SUBJECT: Triangle Expressway Southeast Extension (Complete 540) from NC 55 Bypass in Apex to US 64/264 (I-87) in Knightdale, Wake and Johnston Counties; Federal Aid No. STP-0540(19), STP-0540(20), and STP-0540(21); WBS Nos. 37673.1.TA1, 35516.1.TA1, and 35517.1.TA1; STIP Project Nos. R-2721, R-2828, and R-2829

Action ID No. SAW-2009-02240; Complete 540; TIP R-2828

Also, please reference your February 26, 2021 letter, requesting modification of the permit to authorize impact changes due to an erosion issue, construction method design revisions, and construction access, for Permit Sites 32, 48, 49, and 91, within Section R-2828, as indicated in Revised Table 4, below (Temp. Wetlands impacts include non-404 hand clearing).

Subject: MODIFICATION of 401 Water Quality Certification Pursuant to Section 401 of the Federal Clean Water Act, NEUSE BUFFER RULES, and ISOLATED WETLANDS PERMIT Pursuant to IWGP100000 with ADDITIONAL CONDITIONS for Proposed construction of the Triangle Expressway Southeast Extension (NC 540) in Wake & Johnston Counties, Federal Aid Project No. STP-0540(19-21), State Project No. 37673.1.TA2, TIP Nos, R-2721, R-2828, & R-2829.  
NCDWR Project No. 20181249 version

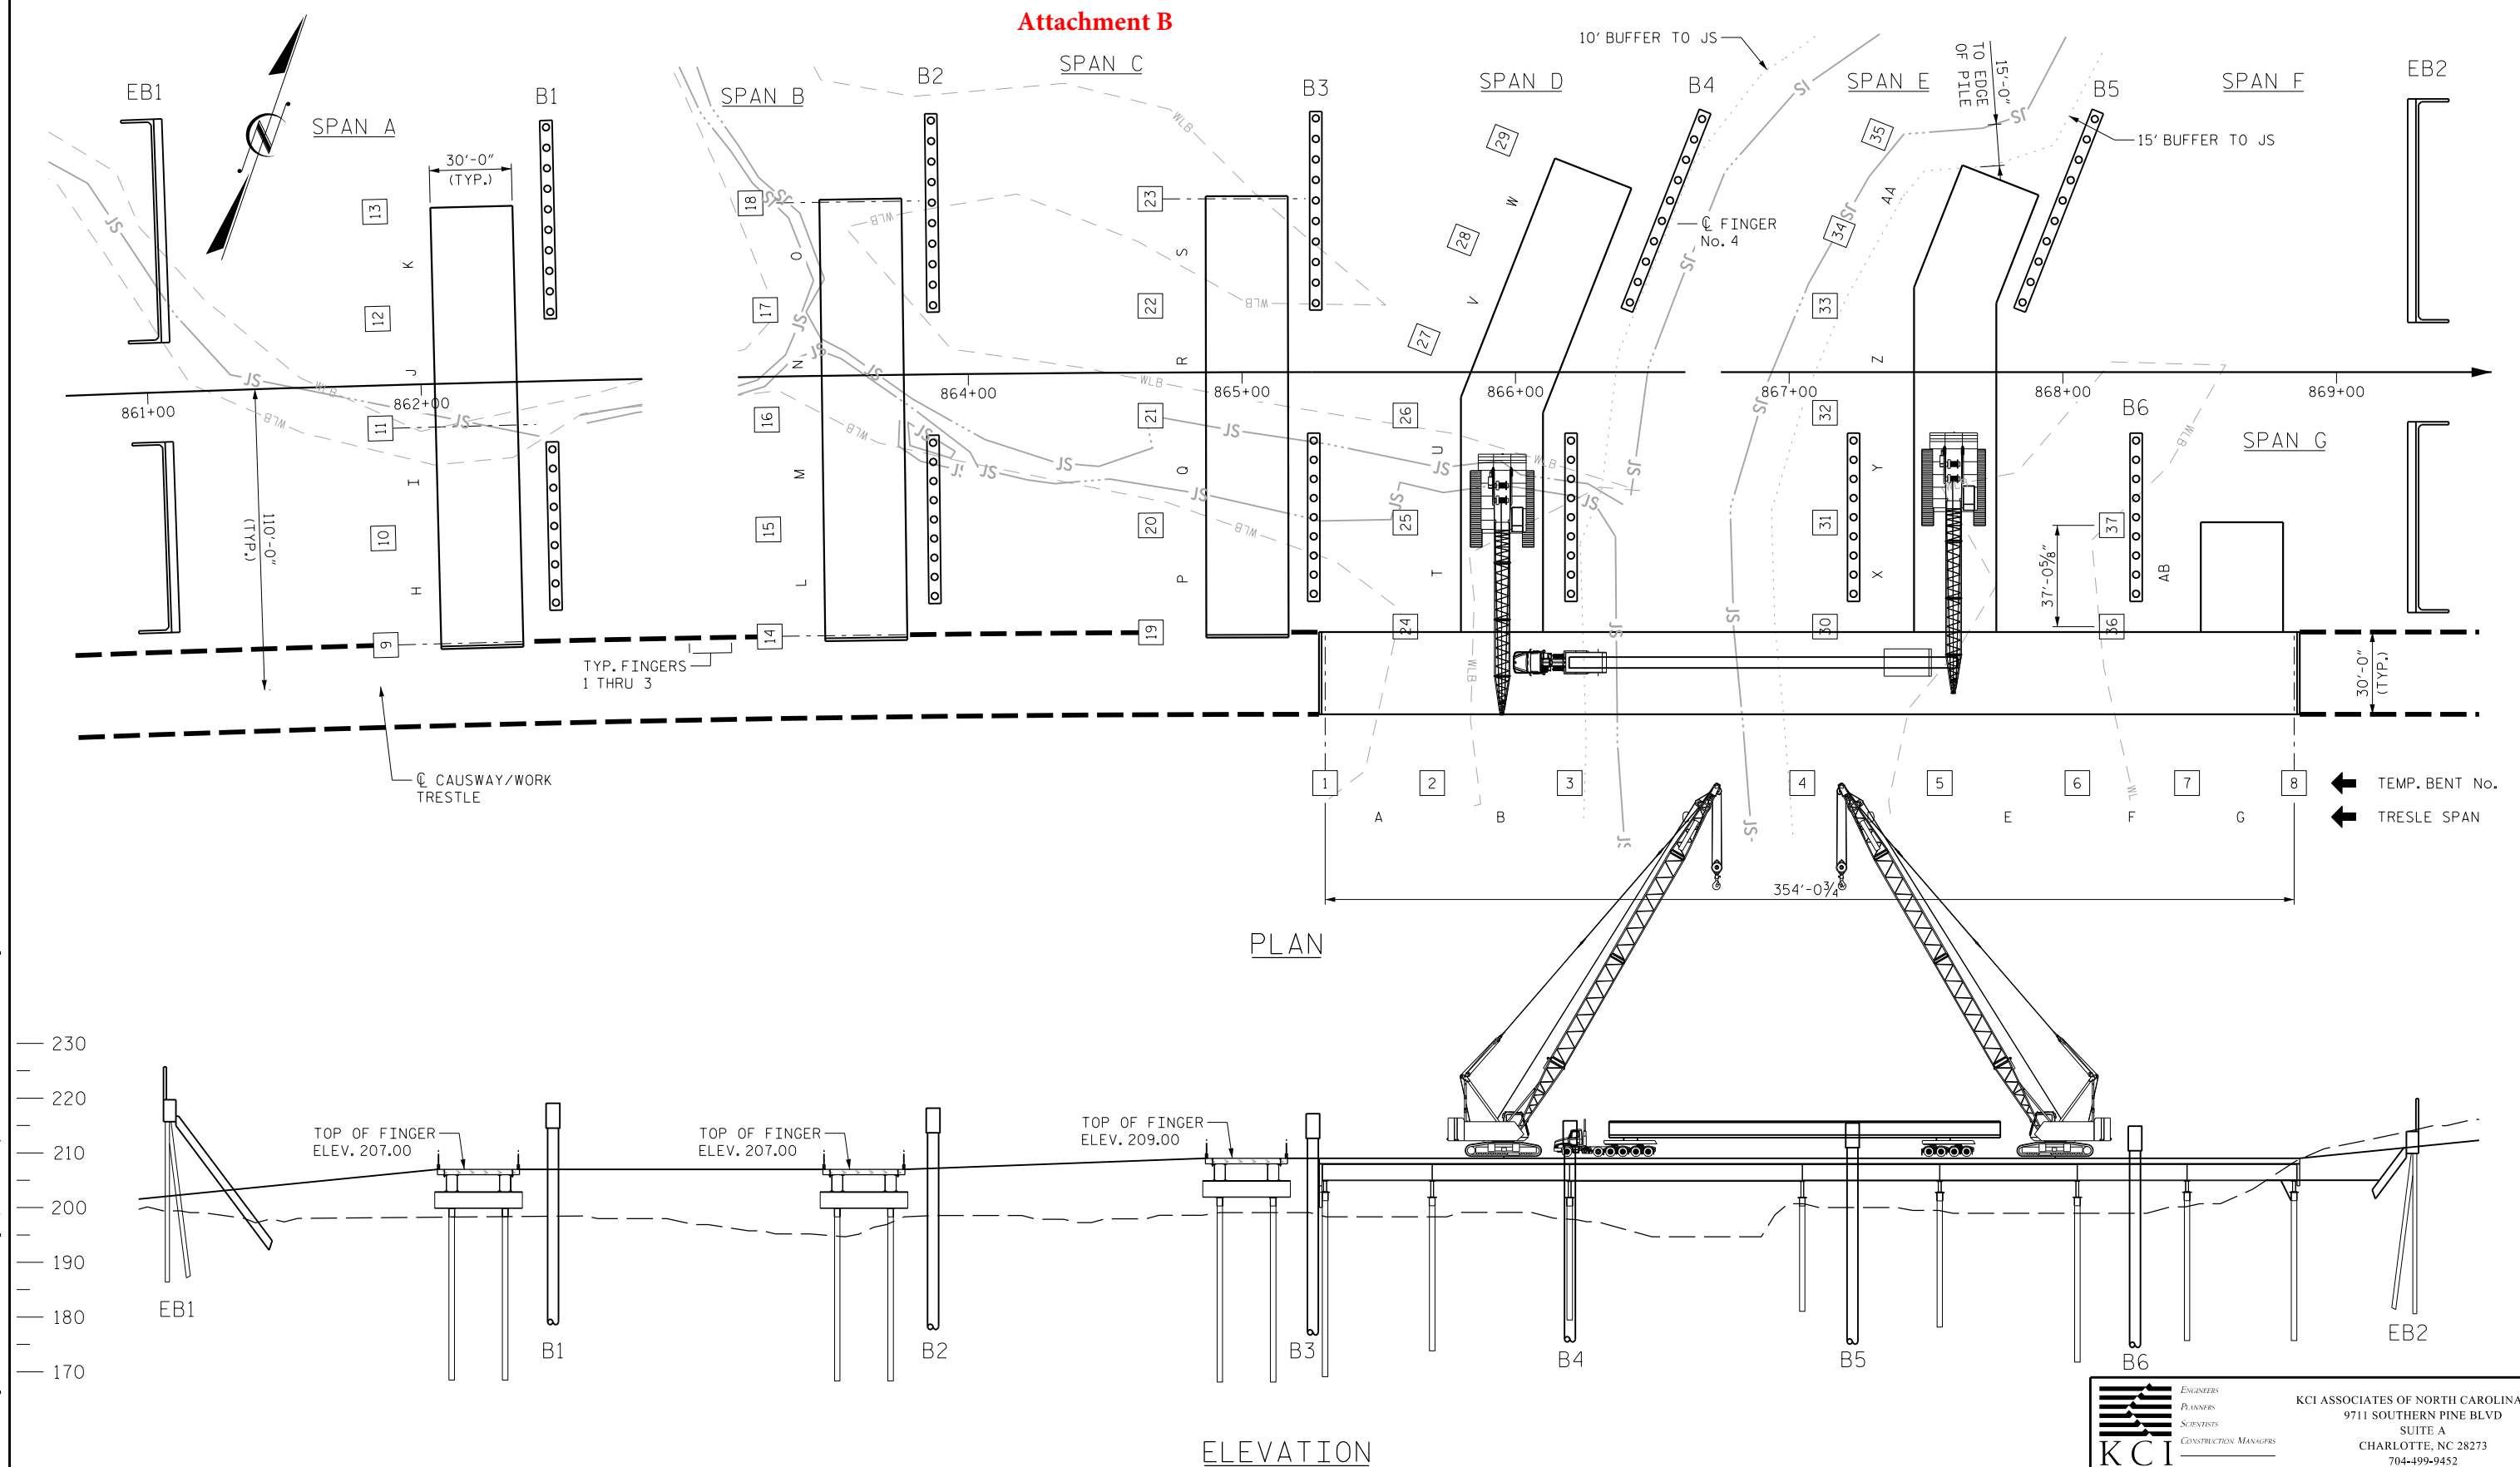
**Section R-2828 Additional Stream Impacts**

| <b>R-2828 Site</b>      | <b>Riprap Stabilization to Stream (linear ft)</b> | <b>Temporary Fill in Stream (linear ft)</b> |
| <b>32</b>               | <b>22</b>                                         | <b>-</b>                                    |

**Section R-2828 Additional Wetland Impacts**

| <b>R-2828 Site</b>      | <b>Hand Clearing in Wetland (ac)</b> |
| <b>48</b>               | <b>0.014</b>                         |
| <b>49</b>               | <b>0.060</b>                         |

PERMIT DRAWING  
SHEET 74 OF 171

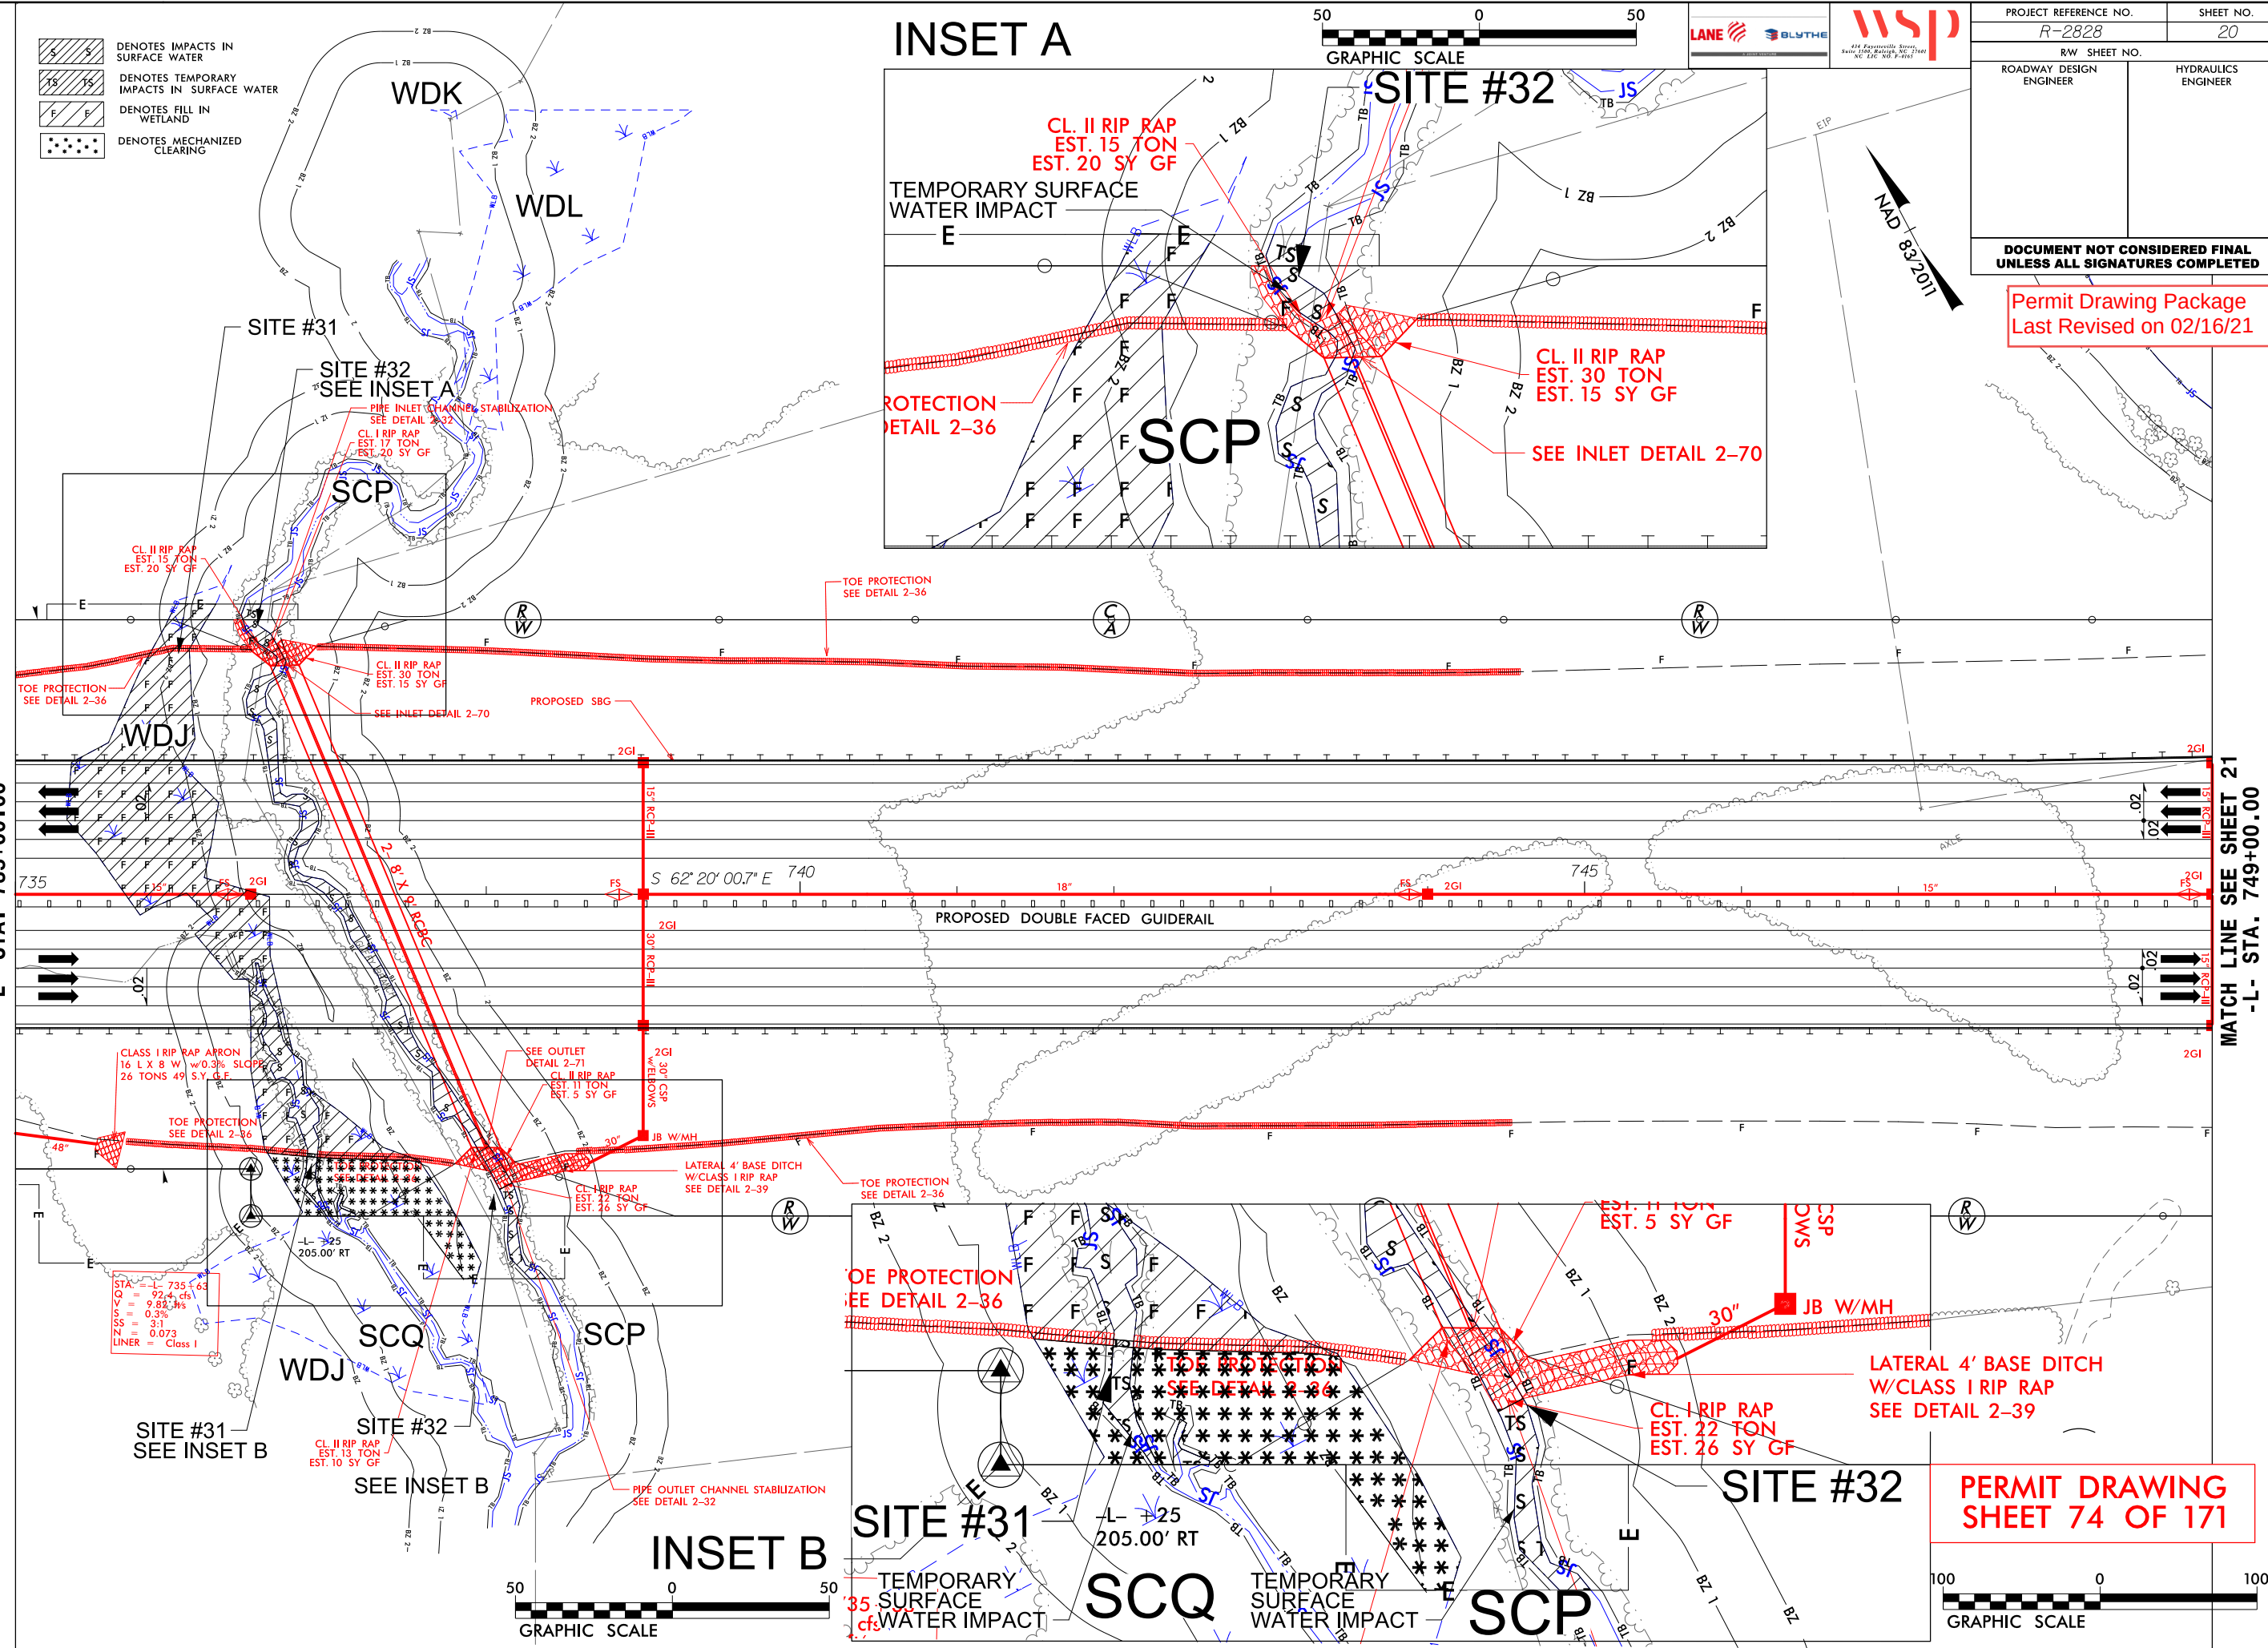
The Corps has completed the evaluation of your request and has determined that it is appropriate and reasonable, and no public notice is required for this modification. Therefore, the permit is modified as requested and as shown on the enclosed revised Permit Drawings, Sheets 1, 74, 75, 105, 106, 107, 111, 112, 132, 133, 168, 169, and 171 of 171, labeled "Permit Drawing Package Last Revised on 02/16/21."
